ADDENDUM NO. 2

Addendum Date: May 22, 2014
Invitation to Bid (ITB) 14-0217

REPLACEMENT OF CENTRAL ENERGY PLANT BOILERS AT THE LAKE COUNTY DETENTION CENTER

SUPPLEMENT TO DRAWING No.: M-3

MIXING VALVE REVISIONS

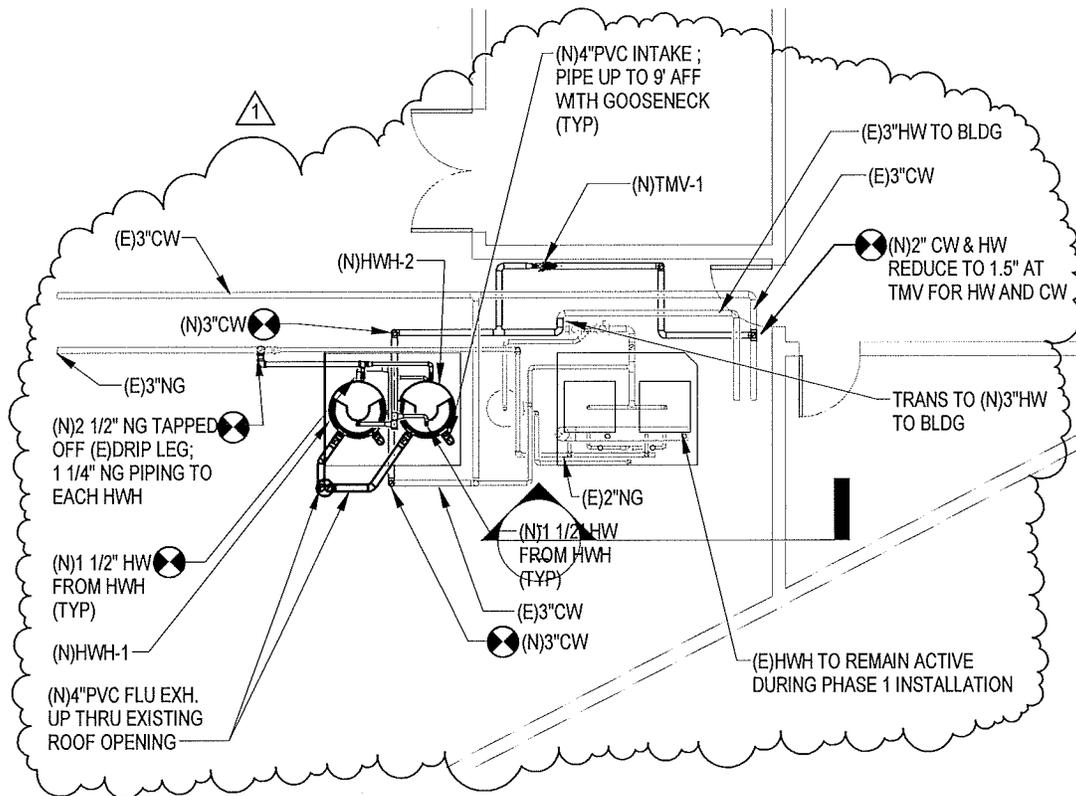
1. There will be a need to complete the switchover to the new equipment at a time when water use at the facility is minimal. The timeframe for this effort will be from 11:00 PM to 2:30 AM on the night of switchover.
2. Revision of certain installation effort was discussed and is described on the attached supplement to drawing M3.
3. Use of "pro press" copper fittings was approved.
4. It was confirmed that current openings for exhaust vents could be utilized with rain caps installed as required.
